Application for Licence Amendment

Licence Number	L5206/1987/10
Licence Holder	Wiluna Operations Pty Ltd
ACN	166 954 525
File Number	2012/006906-1
Premises	Wiluna Mine Site WILUNA WA 6646 Legal description – Being Mining tenements M53/30, M53/32, M53/468, L53/62, L53/20, M53/64, G53/18 and G53/19 part tenements M53/40, M53/44, M53/50, M53/26, M53/6, M53/95, M53/96, M53/200, M53/69, M53/24 L53/50 and L53/77 as defined by the coordinates in Schedule 2.
Date of Report	18 November 2021
Decision	Revised licence granted

Figure 2: Groundwater monitoring bores surrounding TSF K.

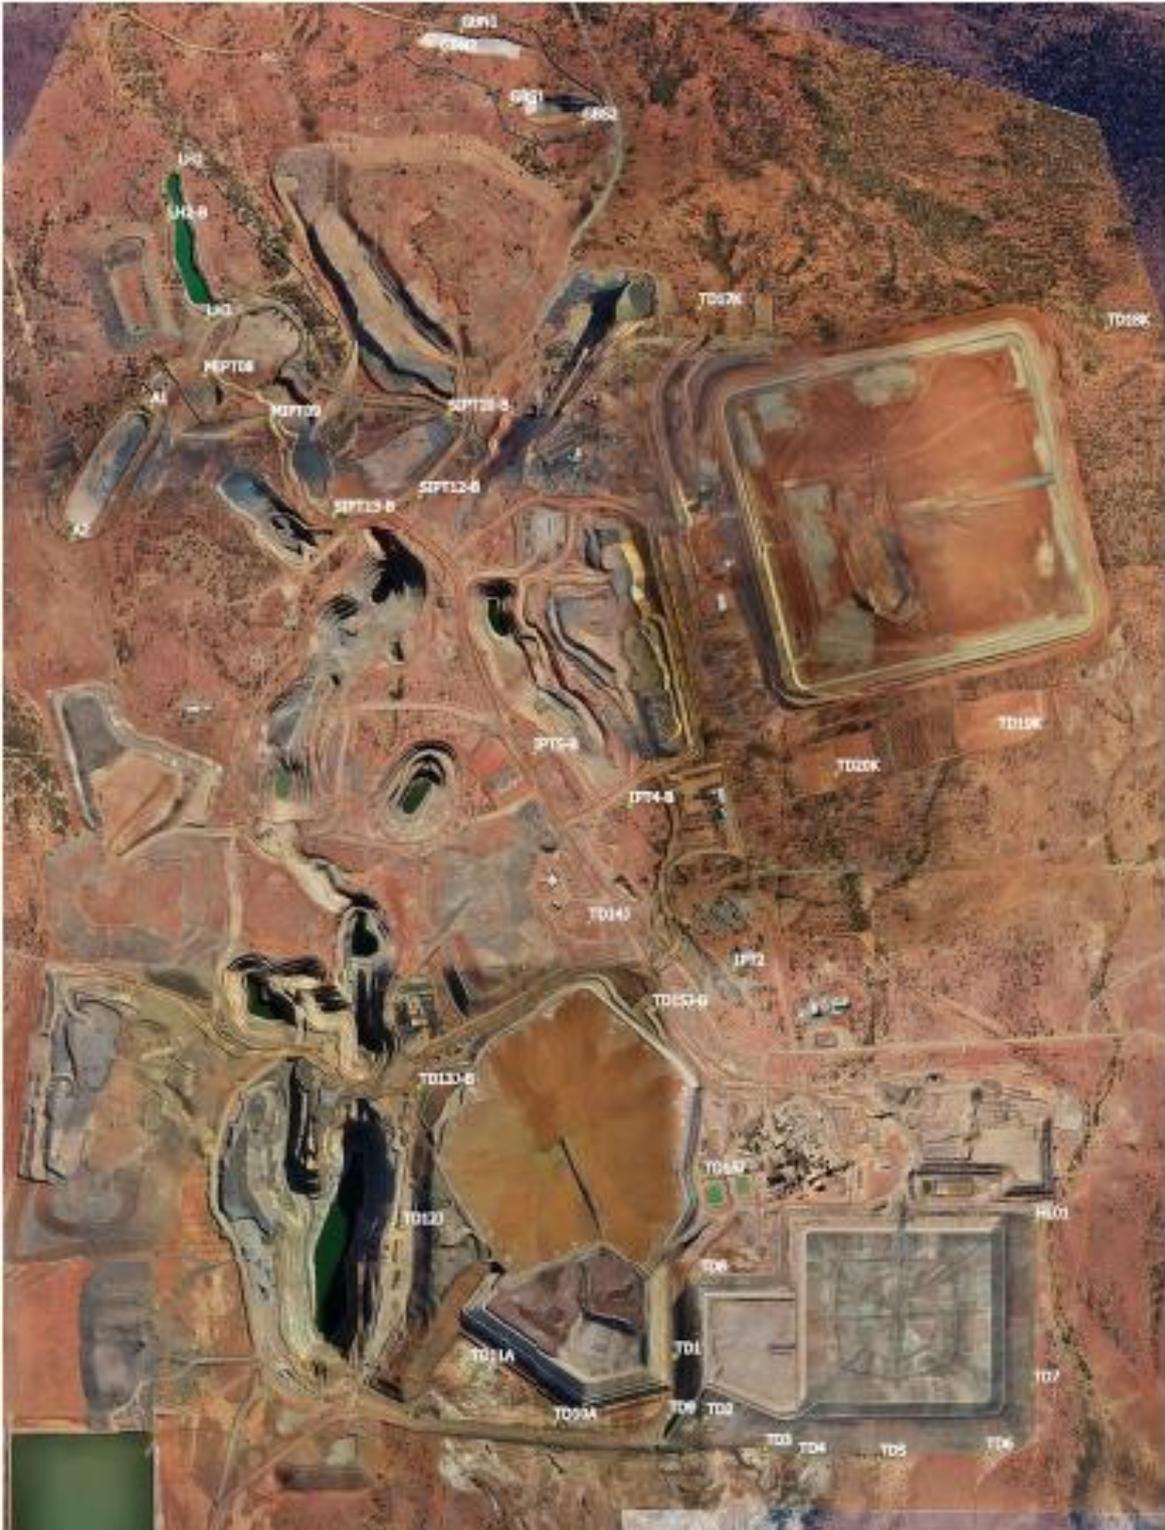
Figure 2 demonstrates the location of the four groundwater monitoring bores adjacent to TSF K. The most recent data obtained from the four new monitoring bores indicate groundwater depths ranging from 9 mbgl recorded at TD19K located to the southeast of TSF K and 36.7 mbgl at TD17K located to the northwest (Wiluna Operations Pty Ltd, 2021). It is difficult to ascertain trends in the SWL's surrounding TSF K, given the four monitoring bores have only been operation since June 2020, therefore there is limited data available. However, a review of SWL data to date, shows that TD19K and TD 20K have seen a rise in SWL over the last year, with TD19K rising 7.24 mbgl to 9 mbgl and TD 20K rising 2.54 m. TD19K and TD20K are located on the south side of TSF K to detect potential leakage migrating to the south towards Lake Violet. Noting SWL are on a rising trend and noting the presence of nearby sensitive receptors (localised native vegetation), an assessment of the potential impacts to sensitive receptors has been undertaken under Section 3.2.5.

TDS and 47,000 TDS respectively. Groundwater was previously recorded in these bores as fresh at 760 TDS (TD19K) to brackish at 4000 TDS (TD20K). This increase in TDS could be the result of impacts from seepage from the TSF, although this is difficult to confirm with only one years worth of data to assess.

Although there are existing controls on the licence (i.e. groundwater monitoring requirements) to manage the impacts of groundwater mounding, the analysis of groundwater monitoring data indicates that SWL may be raising, particularly in TD19K and TD20K which have seen significant increases. Tailings slurry and return (decant) water contain soluble metals and metalloids which are toxic to native vegetation and fauna. Should seepage rise to the root zone of adjacent native vegetation (expected to be at least 4mbgl) stress or death of deep-rooted vegetation may result due to impacts from the saline water. Therefore, the Delegated Officer has determined that it would be appropriate to add a SWL limit of 4mbgl for the groundwater monitoring bores surrounding TSF K. Condition 3.4.1 (Table 3.4.3) has been amended to include a limit for SWL of 4mbgl for TSF K monitoring bores TD17K, TD18K, TD19K and TD20K. This will ensure that SWLs are managed, and groundwater mounding does not result in SWL increasing too close to the surface, impacting upon native vegetation.

Condition 3.4.1	Table 3.4.3 (Monitoring of ambient groundwater quality) has been amended to include a limit for SWL of 4mbgl for TSF K monitoring bores.
Conditions 4.2.3 and 4.2.4	Reporting requirements related to the construction of TSFJ specified under Table 1.2.4 have been removed and replaced with conditions 1.2.8 and 1.2.9.
Schedules 2 to 4	Amended to include Design Drawings and Map showing location of diversion drain alignments for TSF K Stage 2 embankment raise (now listed under Schedule 2).
